PERMIT

ON-SITE SEWAGE DISPOSAL SYSTEM HOWARD COUNTY HEALTH DEPARTMENT BUREAU OF ENVIRONMENTAL HEALTH

ADDRESS: 14811 Chestnut Court PROPERTY OWNER: WM Passmore

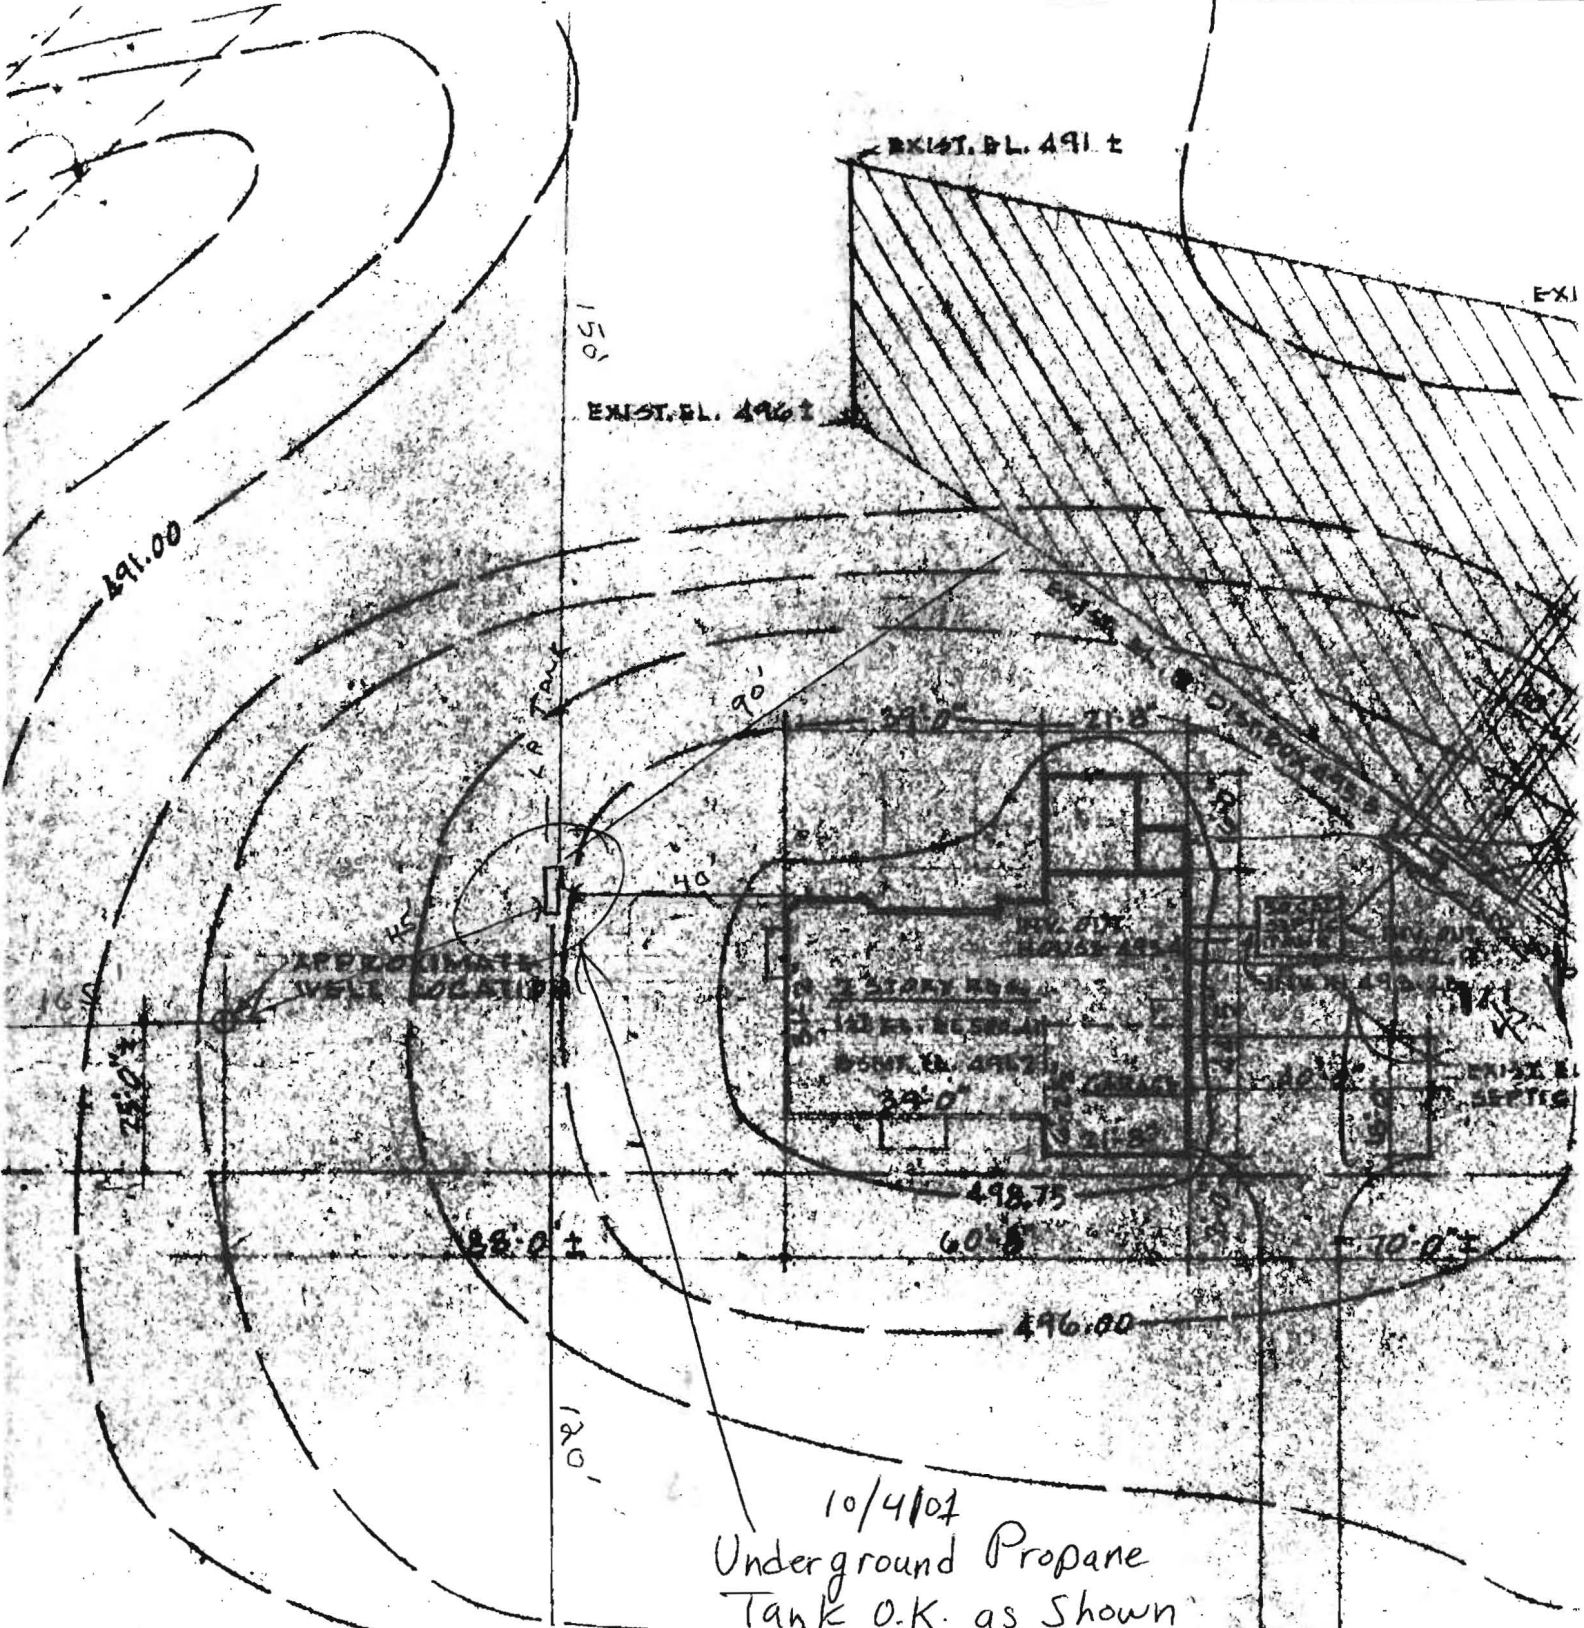
PRE-CONSTRUCTION 3/3/03 - DUG PERC HOLE IN LOCATION (A) SEE SOIL PROFILE, POOL
 OF EXISTING
 INSTALLATION SYSTEM TRENCHES (INFILTRATOR INSTALLED) VERT CLOSE TO EX. POOL,

REPAIR USING NEW DESIGN CRITERIA, TANK NEEDS TO BE MOVED DUE TO PROP.

GARAGE - (SRK, JB, FA) SRK

3/24/03 (2) 60' TRENCHES INSTALLED; MANHOLE RISER, BAFFLES NOT YET INSTALLED;
 SCHEDULED APPOINTMENT FOR 12:30 FINAL ON 3/25/03. KN/FA

3/25/03 House comm made. Perc hole (A) 10' uphill from front trench

10/4/04
 Underground Propane
 Tank O.K. as Shown
